Vectorbeam Warrior Reproduction Audio PCB v1.1

Revision History

1.1: March 2017

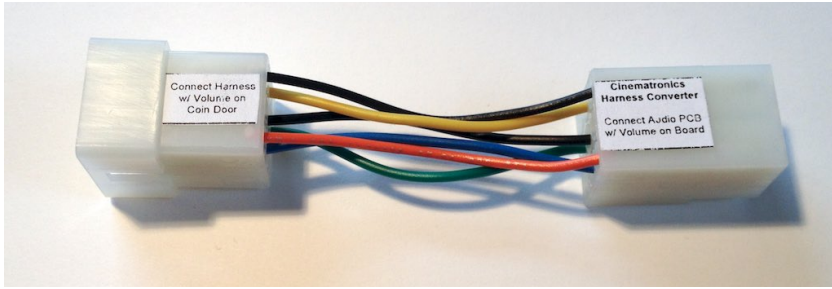
5. Upgraded Voltage Regulation Circuits. The original Warrior voltage regulation circuits used tantalum capacitors, which were prone to failure. This circuit was upgraded by Cinematronics beginning with the Rip Off audio board, replacing each of the 3.3uf tantalum capacitors with 22uf electrolytic capacitors and a .1uf ceramic disc capacitor. The circuit was further refined in boards such as Star Castle and Armor Attack, adding four 1N4003 diodes to the circuit. The Warrior Reproduction Audio PCB v1.1 uses this final revision of the circuit.

Upgrades to the Voltage Regulation Circuits:

Changed C22,C23,C24,C25,C26 to “22uf 50v Elec” and changed part for a better fit for the caps.

Added C44,C45,C46,C47,C48: .1uf ceramic disc caps.

Added D8,D9,D10,D11: 1N4003 Diodes.

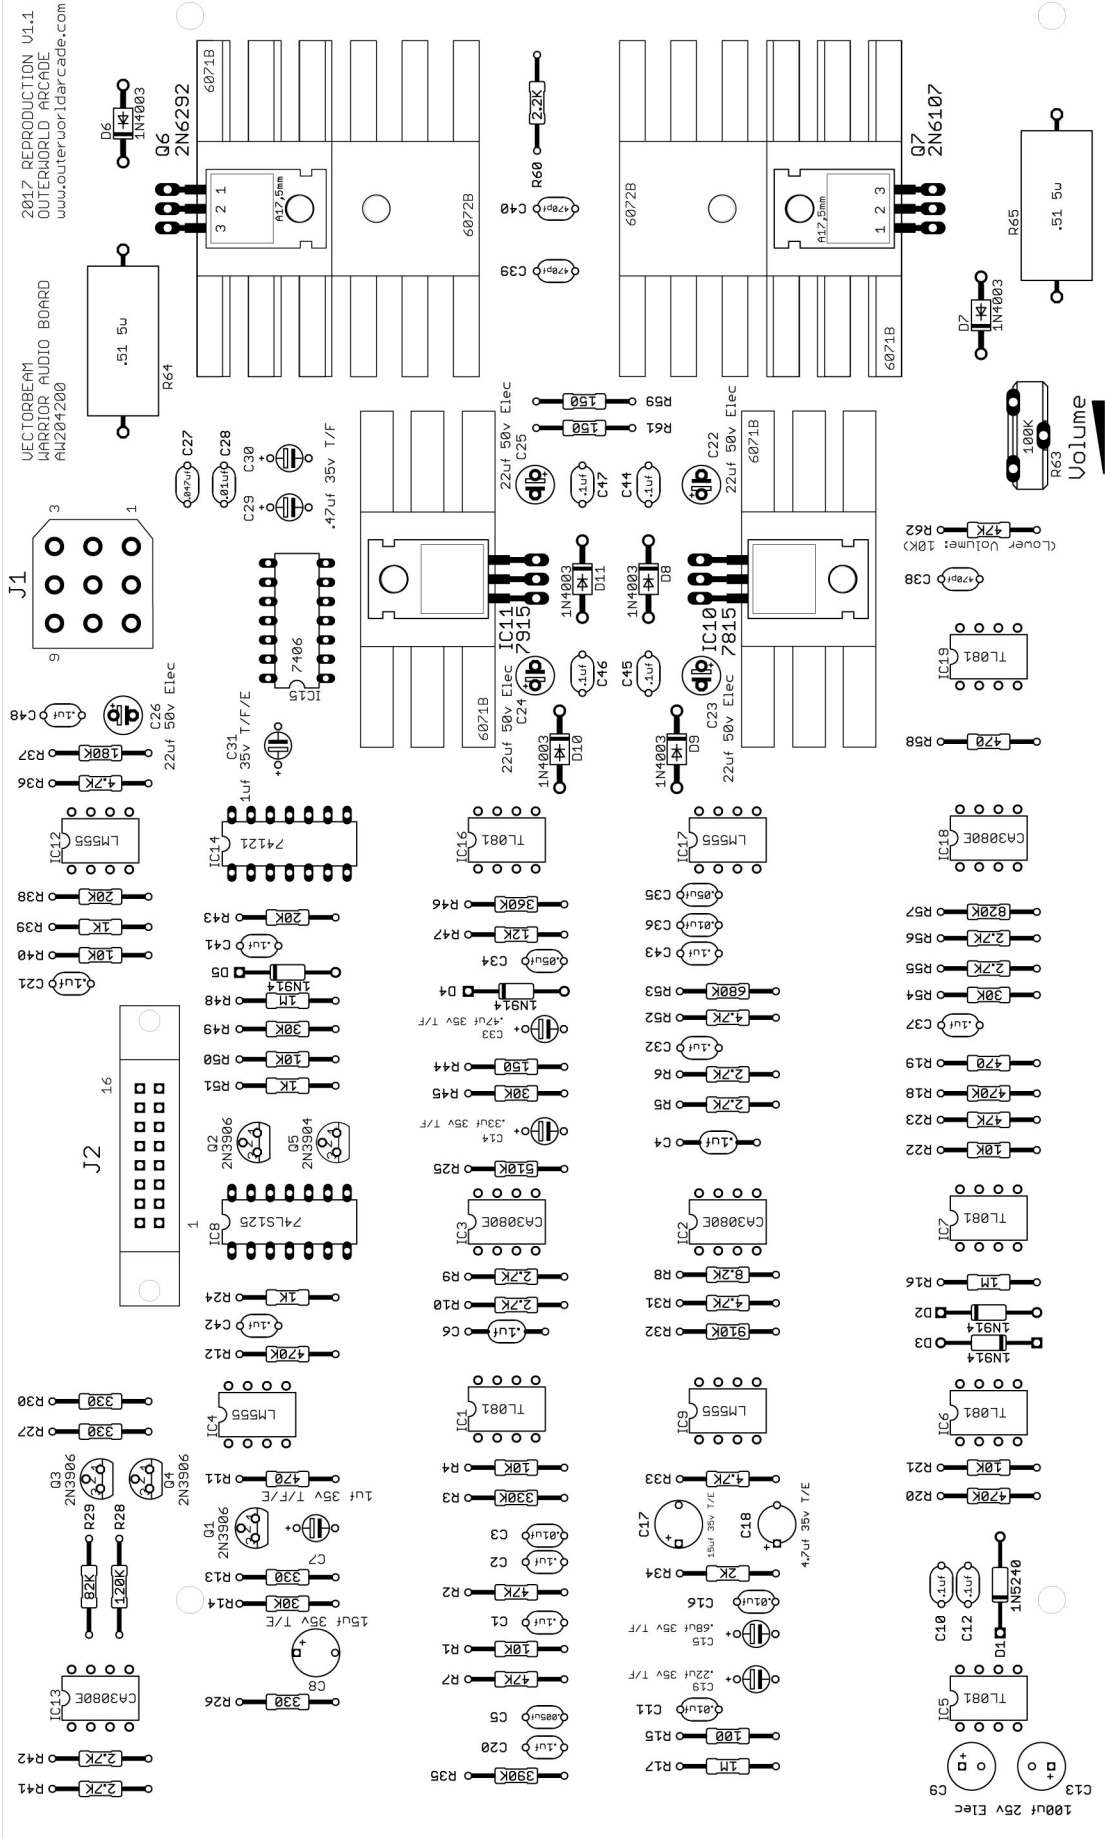
Corrected Errors in Component Values On Board. Vertical labels are read from the right side of the board rather than the left. This is because the board was submitted to the manufacturer vertical (1.0) rather than horizontal (1.1).

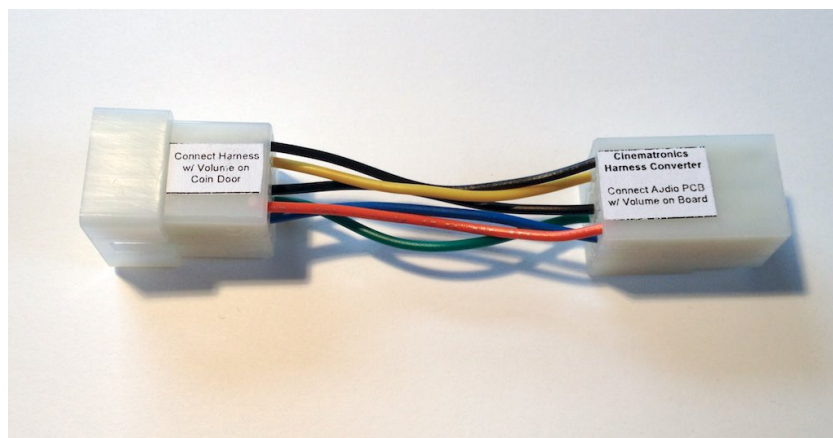
Trace to pin 2 of Q7 (2N6107) routed from top to bottom of board to prevent any short circuits between heatsink and trace. R65 moved down and to the left to allow more space between it and Q7.

J1 Moved to the right to allow a bit more finger space for plugging and unplugging and to save on wear and tear on components close to the connector. Made diameter of pad around each hole larger.
